Southern Nuclear Operating Company
Vogtle Electric Generating Plant Units 3 and 4 Combined License Application
Revision to Final Safety Analysis Report Sections 2.5 and 3.7

Enclosure:
VEGP Units 3 and 4 COL Application Revision to FSAR Chapters 2 and 3 Regarding
Heavy Lift Derrick Foundation

Regarding Heavy Lift Derrick Foundation

FIGURE 2.5-203 HEAVY LIFT DERRICK FOUNDATION LOCATION

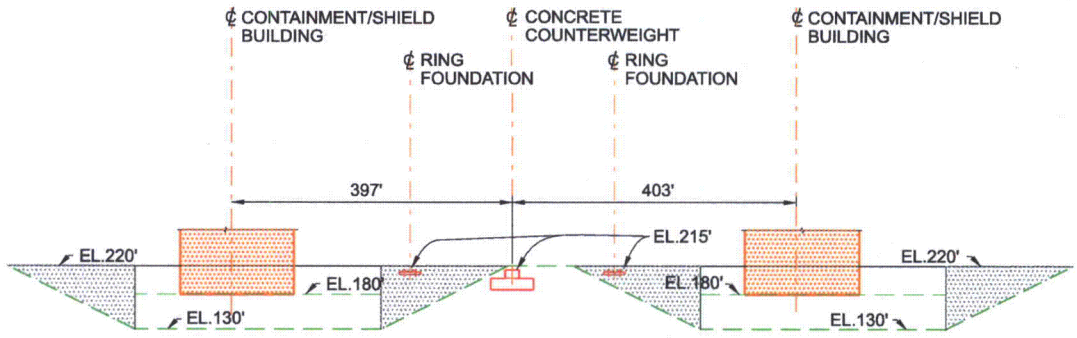
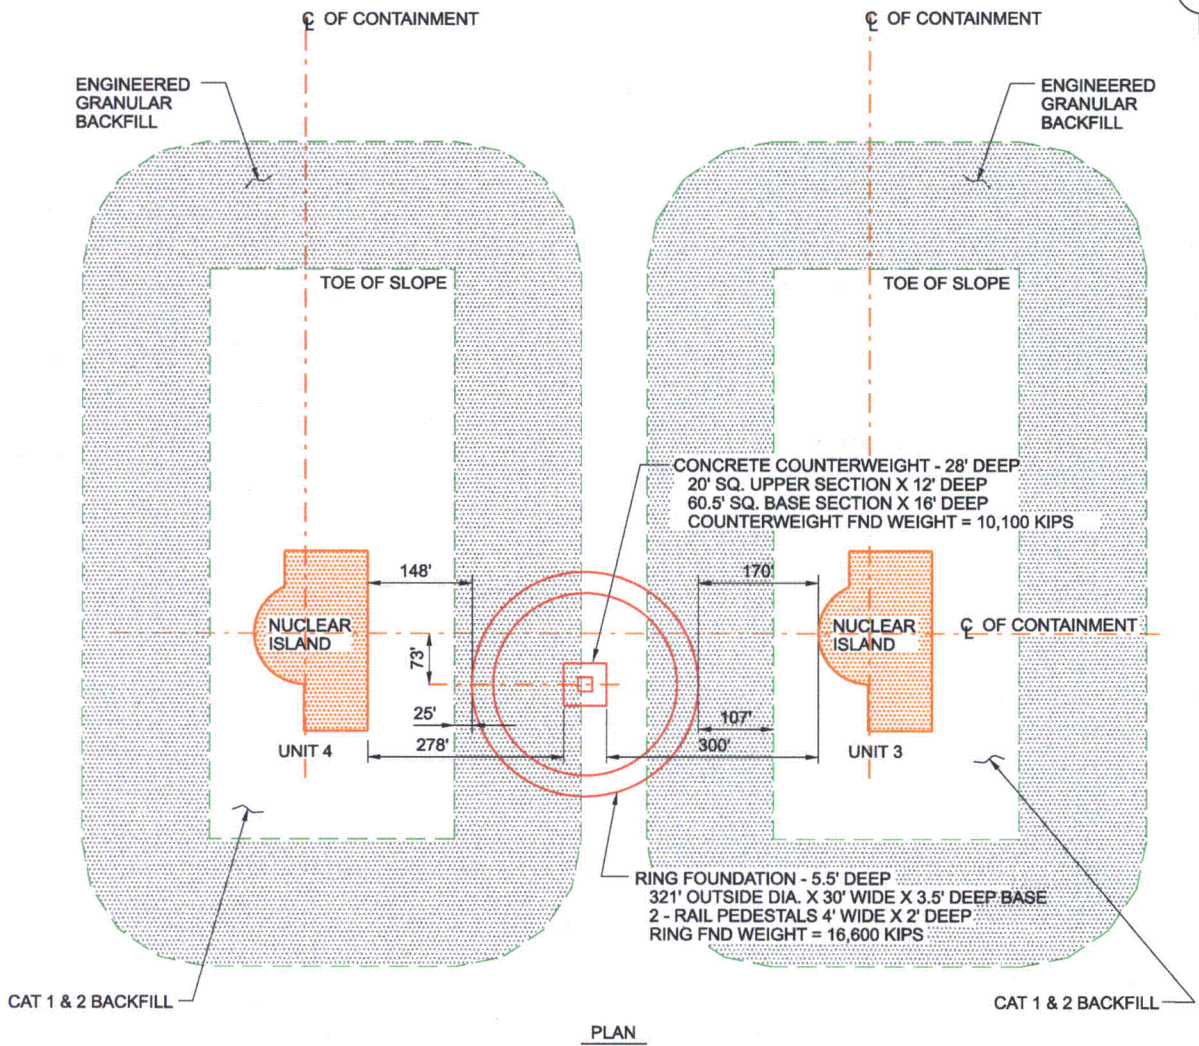
The ring foundation for the heavy lift derrick (HLD) and counterweight are abandoned in place below grade following construction of Units 3 and 4. The HLD rails are removed from the ring foundation after construction of Units 3 and 4. The (HLD) counterweight and ring foundation are shown on Figure 2.5-203.

The top of the HLD counterweight and ring foundation concrete is located at approximately elevation 215 ft MSL, which is five feet below the nominal site grade of 220 ft MSL. The HLD counterweight and ring foundation are not visible following the installation of the roads, drainage provisions, and ground surface cover.

The HLD counterweight and ring foundation are below the surface drainage system provisions and do not affect the runoff for the local PMP flood event discussed in Subsection 2.4.2.3. The HLD counterweight and ring foundation are located above the design ground water elevation of 165 ft MSL, and do not impact the hydrological analyses described in ESPA SSAR Subsections 2.4.12 and 2.4.13.

As shown on Figure 2.5-203, the HLD counterweight and ring foundation does not extend into the safety-related backfill of either Unit 3 or Unit 4. The ring foundation does extend into the EGB backfill of the excavations for both Unit 3 and Unit 4. The counterweight overall depth is approximately 28 ft. and is below the EGB backfill of the excavation for Unit 4. Subsection 3.7.1.1.1 provides the results of the evaluation which confirms that the presence of the HLD counterweight and ring foundation has no effect on the site specific seismic analyses.

-
2. COLA Part 2, FSAR Chapter 2, Section 2.5, will be revised (with an LMA of VEGP SUP 2.5-1) to include new Figure 2.5-203 as follows:
-
